Access Compliance Report

Public Rights-of-Way

Intersection ID: 14147	Main Street: CHERRY_ST	Cross Street: LUTHER_ST	Location: SE
ADA ID: D1777FE70117	Ramp Type: PerpDiag	Initial Pass/Fail: Fail	Overall Compliance: No
			Severity Score: 18.75

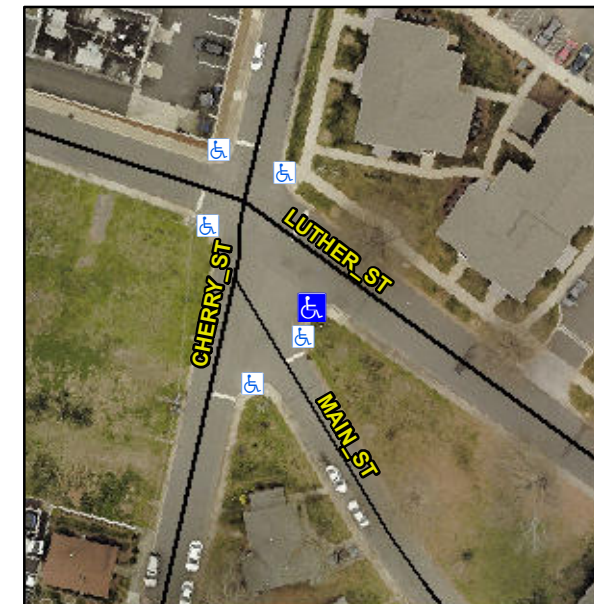
R304.5.1, R304.5.3

Compliance	Description	Data	Compliance	Description	Data
N/A	Ramp Length (in)	60.0	Yes	Ramp Slope (%)	6.3
No	Ramp Width (in)	33.5	No	Ramp XSlope (%)	3.2
N/A	Flare Type LT	N/A	N/A	Flare Type RT	N/A
N/A	Flare Slope LT (%)	N/A	N/A	Flare Slope RT (%)	N/A
N/A	Flare Traversable LT?	N/A	N/A	Flare Traversable RT?	N/A
N/A	Landing Length (in)	N/A	N/A	DWS Provided?	N/A
N/A	Landing Width (in)	N/A	N/A	DWS Contrast?	N/A
N/A	Landing Slope (%)	N/A	N/A	DWS Length (in)	N/A
N/A	Landing X Slope (%)	N/A	N/A	DWS Full Width?	N/A
N/A	Landing Curb? (Y/N)	N/A	N/A	DWS Offset (in)	N/A
N/A	Shared Landing?	N/A			
N/A	Gutter Ponding?	N/A	N/A	Gutter Slope (%)	N/A
N/A	Gutter Lip Ht (in)	N/A	N/A	Gutter X Slope (%)	N/A
N/A	Painted X Walk1?	No	N/A	Painted X Walk2?	No
	X Walk 1 Direction	To SW		X Walk 2 Direction	To N
N/A	X Walk 1 Width (in)	N/A	N/A	X Walk 2 Width (in)	N/A
	X Walk 1 Slope (%)	3.0		X Walk 2 Slope (%)	1.0
	X Walk 1 X Slope (%)	3.6		X Walk 2 X Slope (%)	3.1

Remove & Replace Curb Ramp With Two New Directional Ramps or Equivalent.
